## **Staff Changes**

This section covers changes proposed by Planning Staff to correct errors and to reflect changes in conversion philosophy based on discussions with the PHED Committee and the Planning Board.

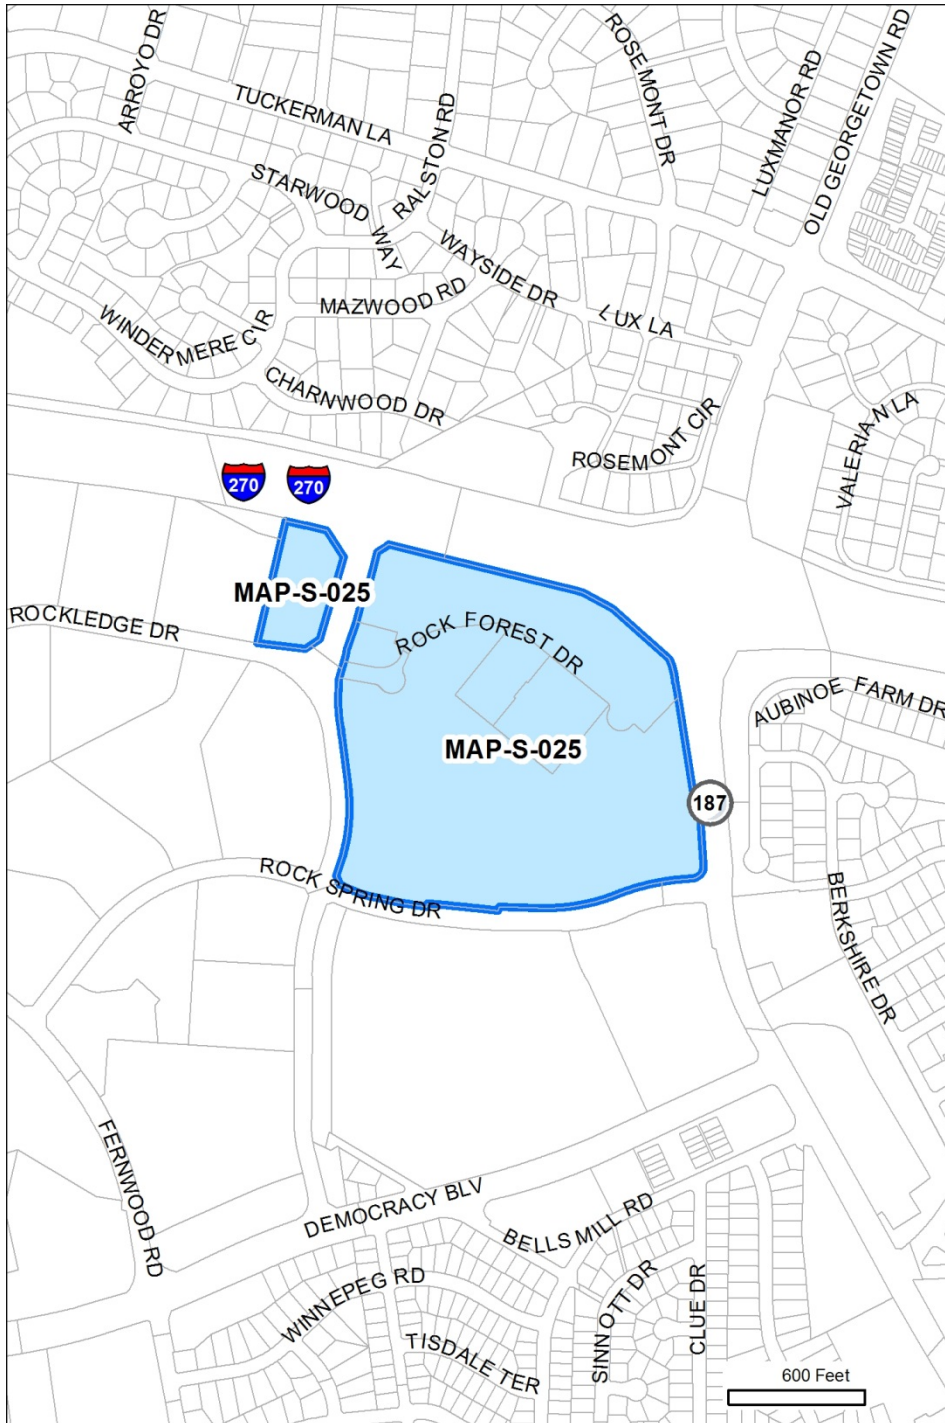
<b>Unique ID:</b> MAP-S-025		staff rec. change
<b>Master Plan ID:</b> 2		
<b>Master Plan:</b>	North Bethesda/Garrett Park	
<b>Location:</b>	Rockledge	
<b>Existing Zone:</b>	MXPD	
<b>Proposed Conv:</b> (5/2)	<del>CRT-1.25 C-0.5 R-0.75 H-100 T</del>	
<b>Prop. Revised Conv:</b>	CR-1.25 C-0.5 R-0.75 H-275 T	
<b>Category:</b>	Staff recommendation	
<b>Modifications</b>	<b>Zone Group:</b>	Changed to CR
	<b>Overall FAR:</b>	No change
	<b>Comm'l FAR:</b>	No change
	<b>Resid'l FAR:</b>	No change
	<b>Height:</b>	Increased to 275'
<b>Reason for change:</b>		
<p><i>Existing development approvals for this site allow buildings up to 275' in height. Because that height is above the statutory height allowed in the CRT zone, the zone needed to be changed to CR to accommodate the additional height.</i></p>

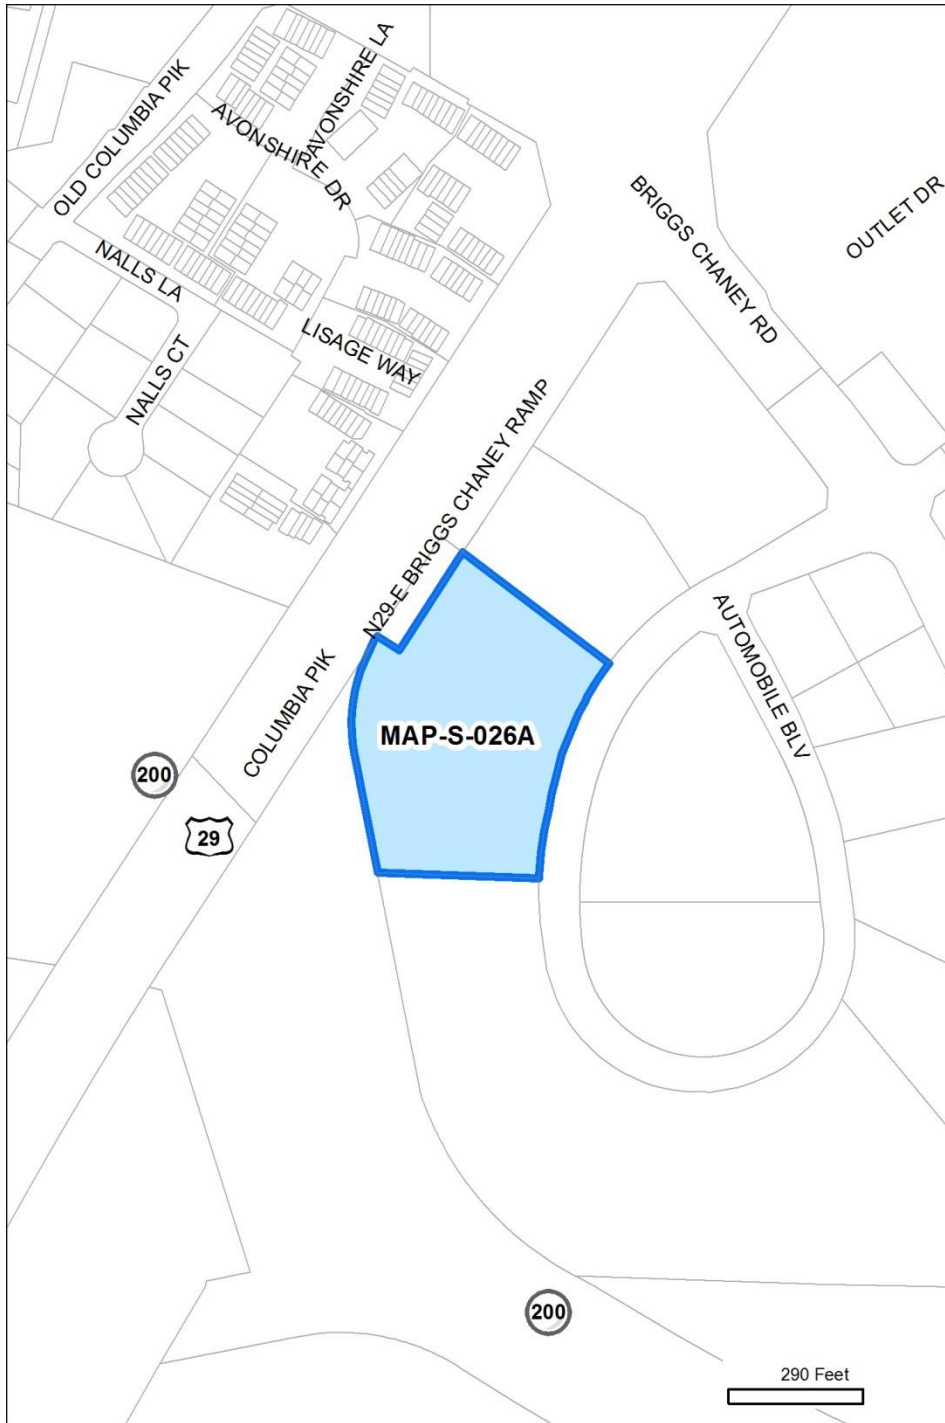
<b>Unique ID:</b> MAP-S-026A		staff rec. change
<b>Master Plan ID:</b> n/a		
<b>Master Plan:</b>		Fairland
<b>Location:</b>		
<b>Existing Zone:</b>		I-1
<b>Proposed Conv: (5/2)</b>		<del>IM-2.5 H-120</del>
<b>Prop. Revised Conv:</b>		IM-2.5 H-50
<b>Category:</b>		Staff Recommendation
<b>Modifications</b>	<b>Zone Group:</b>	No change
	<b>Overall FAR:</b>	No change
	<b>Comm'l FAR:</b>	-
	<b>Resid'l FAR:</b>	-
	<b>Height:</b>	Reduced to 50'
<b>Reason for change:</b>		
<p><i>Since the 5/2 conversion was approved by the Planning Board, staff has received comment from the public and upon further review, believes that the 120' height granted as part of the 5/2 conversion is inappropriate.</i></p> <p><i>The current zoning ordinance allows building heights up to 120' for an "Employment Center", unless the master plan specifically states that an "Employment Center" is inappropriate for the zone – only two master plans contain this restriction.</i></p> <p><i>This provision has been in the code since the last comprehensive revision. Further analysis indicates that buildings up to 120' have not been constructed in the I-1 zone under this provision. Staff proposes a height of 50' for all I-1 property converted to the I-M zone.</i></p>

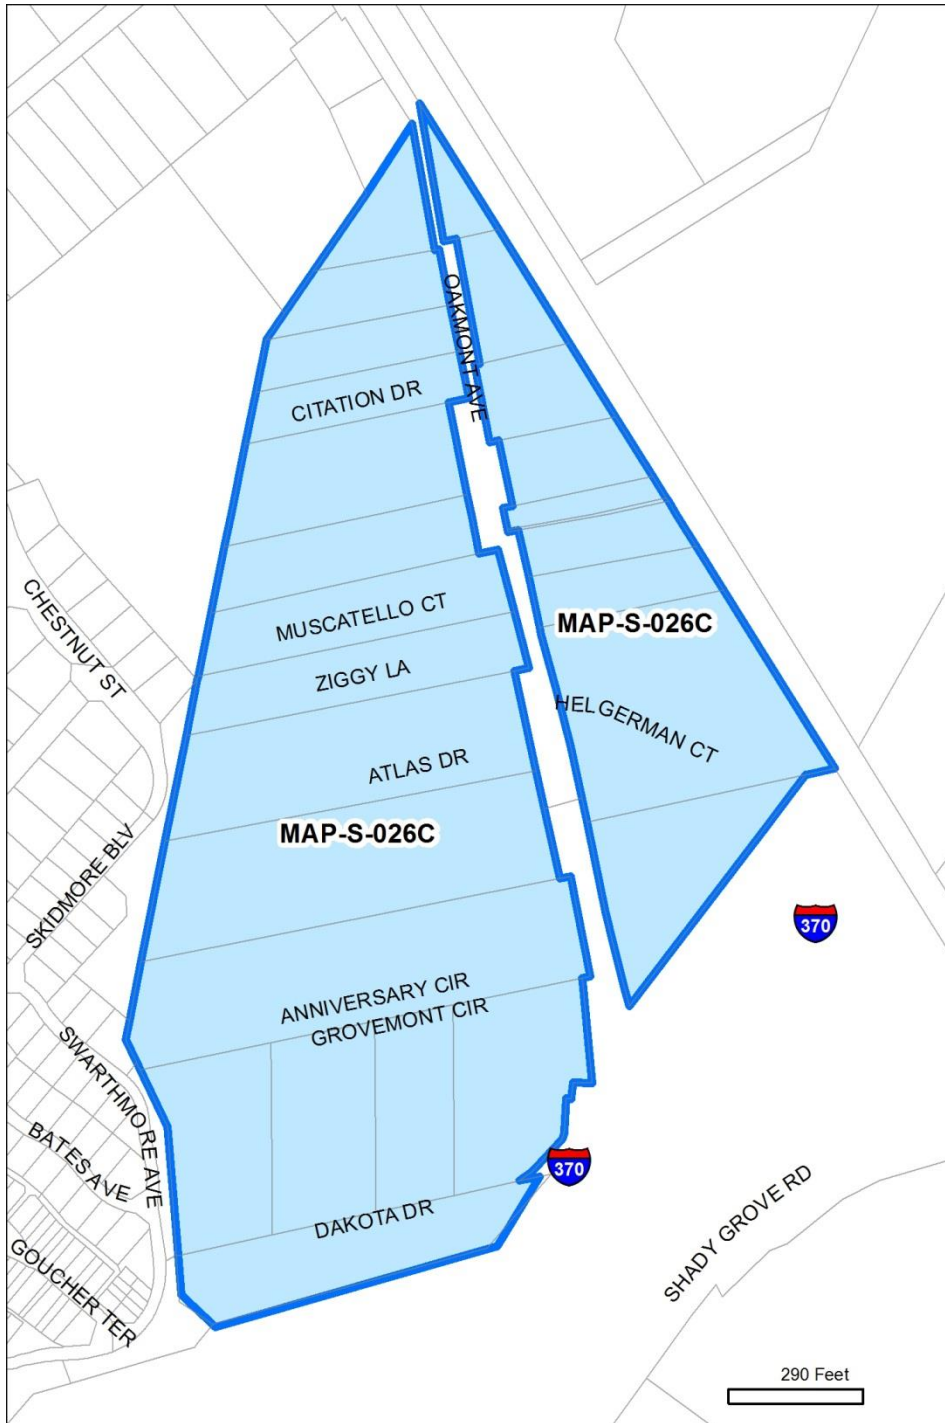
<b>Unique ID:</b> MAP-S-026C		staff rec. change
<b>Master Plan ID:</b> n/a		
<b>Master Plan:</b>	Shady Grove	
<b>Location:</b>		
<b>Existing Zone:</b>	I-1	
<b>Proposed Conv:</b> (5/2)	<del>IM-2.5 H-120</del>	
<b>Prop. Revised Conv:</b>	IM-2.5 H-50	
<b>Category:</b>	Staff Recommendation	
<b>Modifications</b>	<b>Zone Group:</b>	No change
	<b>Overall FAR:</b>	No change
	<b>Comm'l FAR:</b>	-
	<b>Resid'l FAR:</b>	-
	<b>Height:</b>	Reduced to 50'
<b>Reason for change:</b>		
<p><i>Since the 5/2 conversion was approved by the Planning Board, staff has received comment from the public and upon further review, believes that the 120' height granted as part of the 5/2 conversion is inappropriate.</i></p> <p><i>The current zoning ordinance allows building heights up to 120' for an "Employment Center", unless the master plan specifically states that an "Employment Center" is inappropriate for the zone – only two master plans contain this restriction.</i></p> <p><i>This provision has been in the code since the last comprehensive revision. Further analysis indicates that buildings up to 120' have not been constructed in the I-1 zone under this provision. Staff proposes a height of 50' for all I-1 property converted to the I-M zone.</i></p>

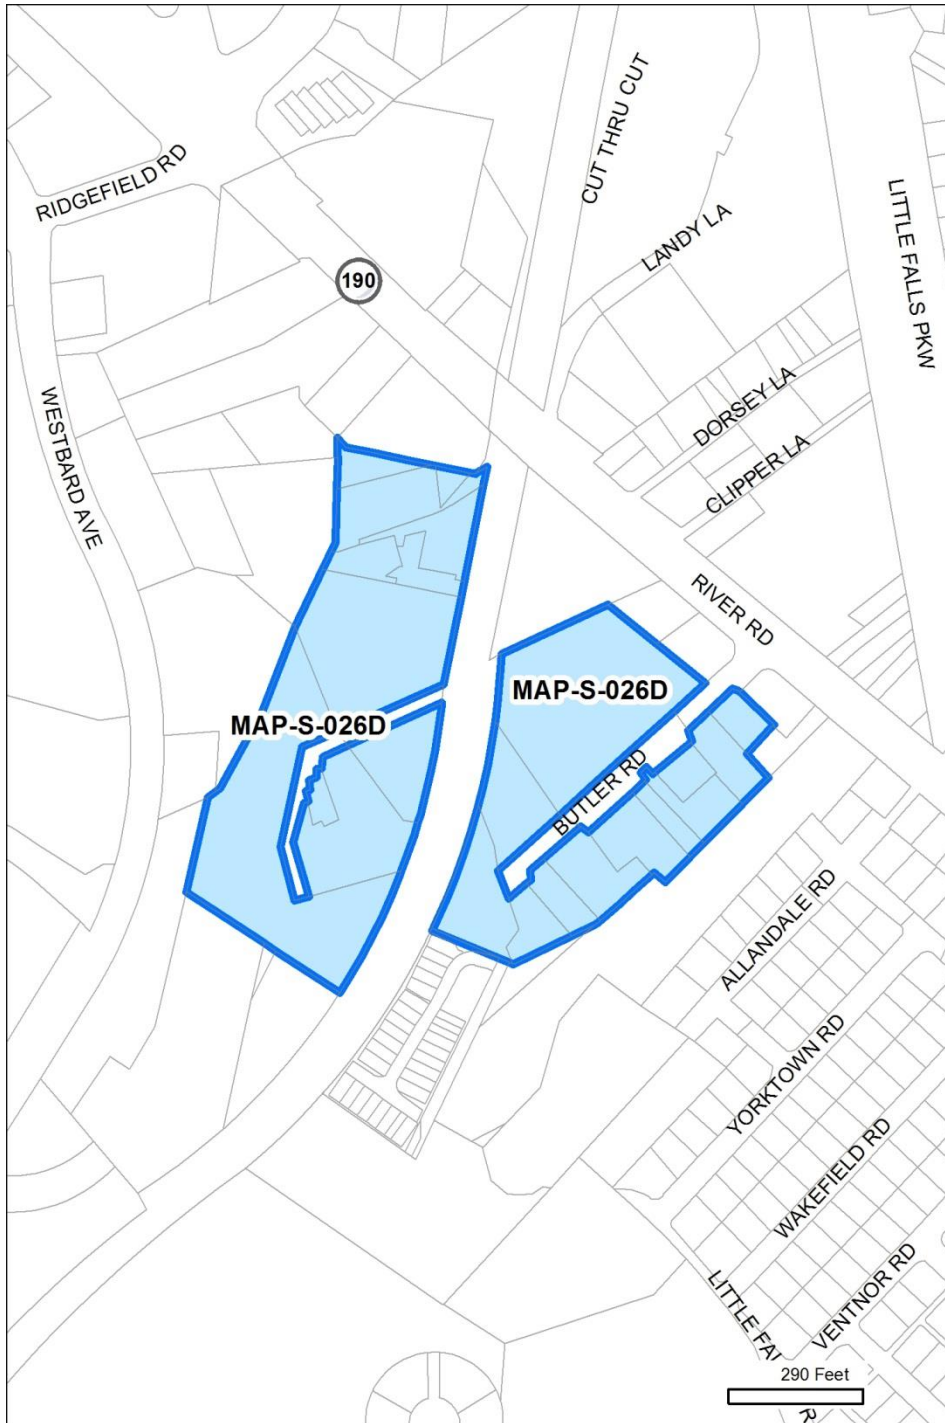
<b>Unique ID:</b> MAP-S-026D		staff rec. change
<b>Master Plan ID:</b> n/a		
<b>Master Plan:</b>		Westbard
<b>Location:</b>		
<b>Existing Zone:</b>		I-1
<b>Proposed Conv: (5/2)</b>		<del>IM-2.5 H-120</del>
<b>Prop. Revised Conv:</b>		IM-2.5 H-50
<b>Category:</b>		Staff Recommendation
<b>Modifications</b>	<b>Zone Group:</b>	No change
	<b>Overall FAR:</b>	No change
	<b>Comm'l FAR:</b>	-
	<b>Resid'l FAR:</b>	-
	<b>Height:</b>	Reduced to 50'
<b>Reason for change:</b>		
<p><i>Since the 5/2 conversion was approved by the Planning Board, staff has received comment from the public and upon further review, believes that the 120' height granted as part of the 5/2 conversion is inappropriate.</i></p> <p><i>The current zoning ordinance allows building heights up to 120' for an "Employment Center", unless the master plan specifically states that an "Employment Center" is inappropriate for the zone – only two master plans contain this restriction.</i></p> <p><i>This provision has been in the code since the last comprehensive revision. Further analysis indicates that buildings up to 120' have not been constructed in the I-1 zone under this provision. Staff proposes a height of 50' for all I-1 property converted to the I-M zone.</i></p>

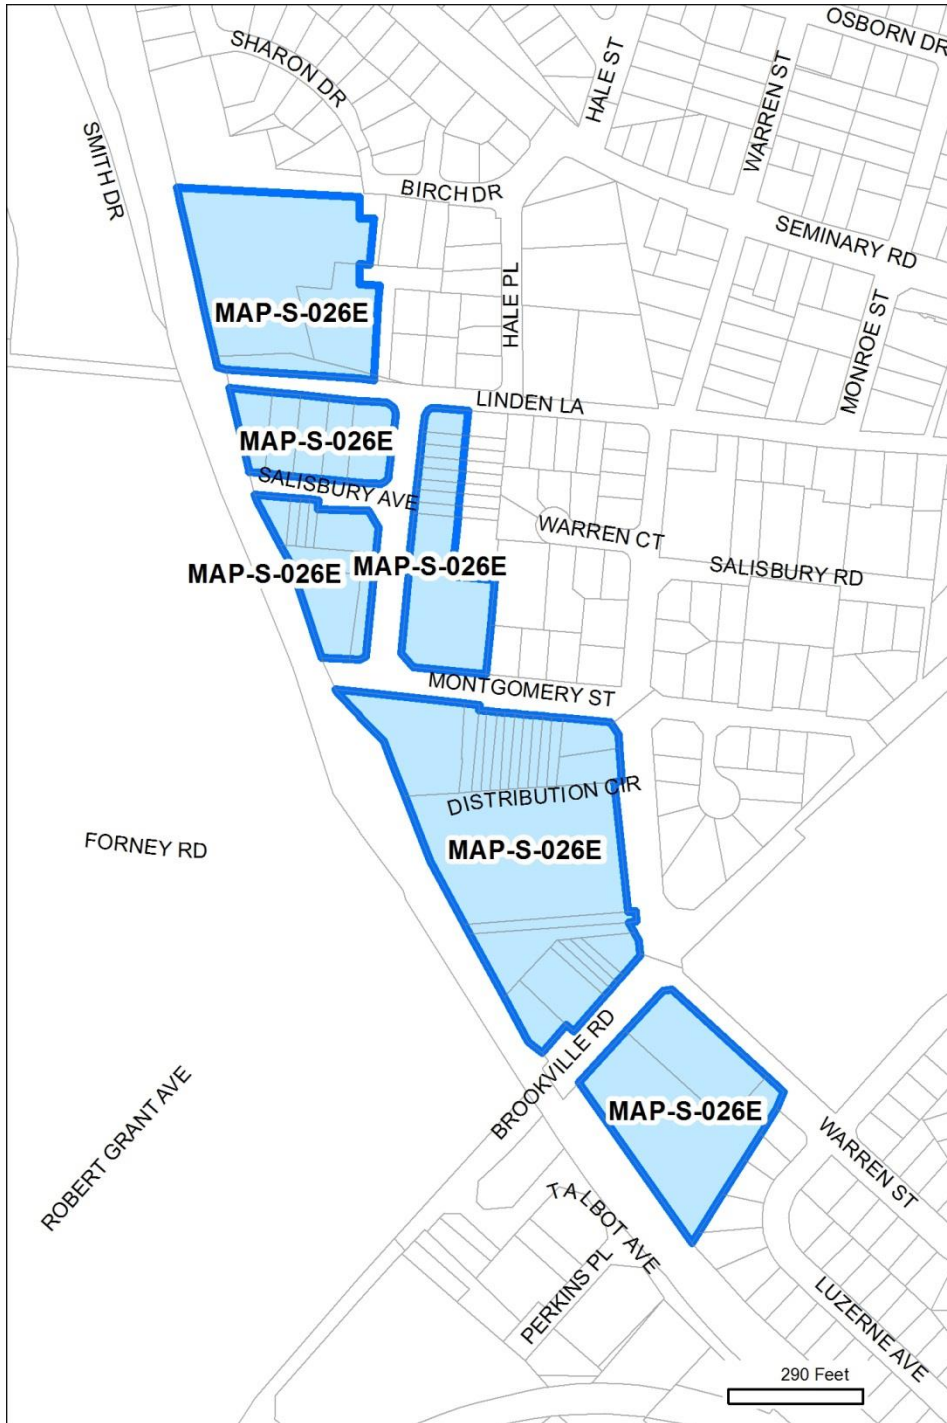
<b>Unique ID:</b> MAP-S-026E		staff rec. change
<b>Master Plan ID:</b> n/a		
<b>Master Plan:</b>		North and West Silver Spring
<b>Location:</b>		
<b>Existing Zone:</b>		I-1
<b>Proposed Conv: (5/2)</b>		<del>IM-2.5 H-120</del>
<b>Prop. Revised Conv:</b>		IM-2.5 H-50
<b>Category:</b>		Staff Recommendation
<b>Modifications</b>	<b>Zone Group:</b>	No change
	<b>Overall FAR:</b>	No change
	<b>Comm'l FAR:</b>	-
	<b>Resid'l FAR:</b>	-
	<b>Height:</b>	Reduced to 50'
<b>Reason for change:</b>		
<p><i>Since the 5/2 conversion was approved by the Planning Board, staff has received comment from the public and upon further review, believes that the 120' height granted as part of the 5/2 conversion is inappropriate.</i></p> <p><i>The current zoning ordinance allows building heights up to 120' for an "Employment Center", unless the master plan specifically states that an "Employment Center" is inappropriate for the zone – only two master plans contain this restriction.</i></p> <p><i>This provision has been in the code since the last comprehensive revision. Further analysis indicates that buildings up to 120' have not been constructed in the I-1 zone under this provision. Staff proposes a height of 50' for all I-1 property converted to the I-M zone.</i></p>

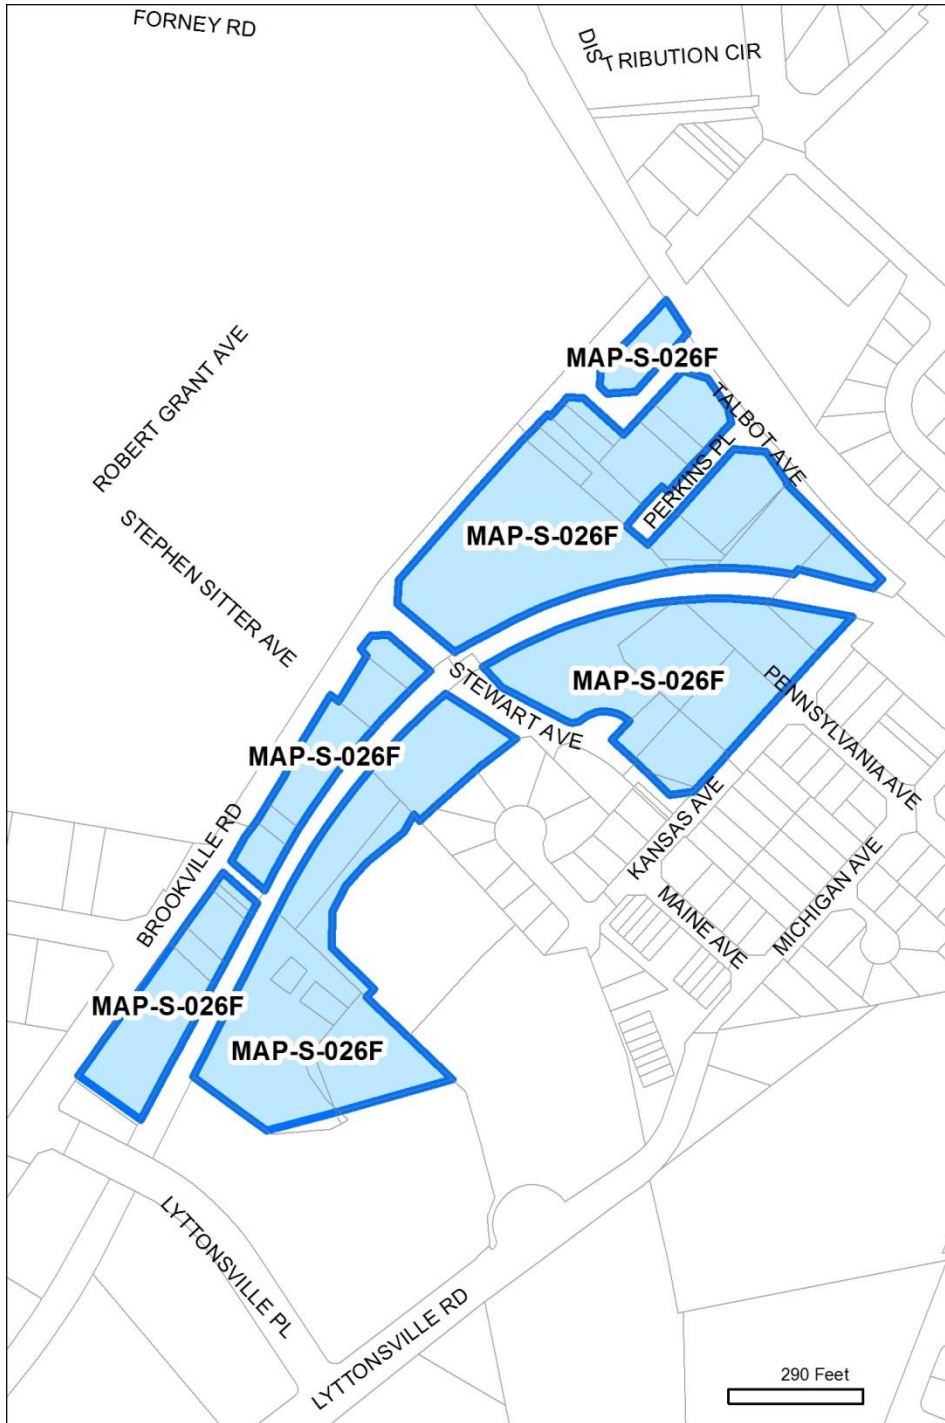
<b>Unique ID:</b> MAP-S-026F		staff rec. change
<b>Master Plan ID:</b> n/a		
<b>Master Plan:</b>	North and West Silver Spring	
<b>Location:</b>		
<b>Existing Zone:</b>	I-1	
<b>Proposed Conv: (5/2)</b>	<del>IM-2.5 H-120</del>	
<b>Prop. Revised Conv:</b>	IM-2.5 H-50	
<b>Category:</b>	Staff Recommendation	
<b>Modifications</b>	<b>Zone Group:</b>	No change
	<b>Overall FAR:</b>	No change
	<b>Comm'l FAR:</b>	-
	<b>Resid'l FAR:</b>	-
	<b>Height:</b>	Reduced to 50'
<b>Reason for change:</b>		
<p><i>Since the 5/2 conversion was approved by the Planning Board, staff has received comment from the public and upon further review, believes that the 120' height granted as part of the 5/2 conversion is inappropriate.</i></p> <p><i>The current zoning ordinance allows building heights up to 120' for an "Employment Center", unless the master plan specifically states that an "Employment Center" is inappropriate for the zone – only two master plans contain this restriction.</i></p> <p><i>This provision has been in the code since the last comprehensive revision. Further analysis indicates that buildings up to 120' have not been constructed in the I-1 zone under this provision. Staff proposes a height of 50' for all I-1 property converted to the I-M zone.</i></p>
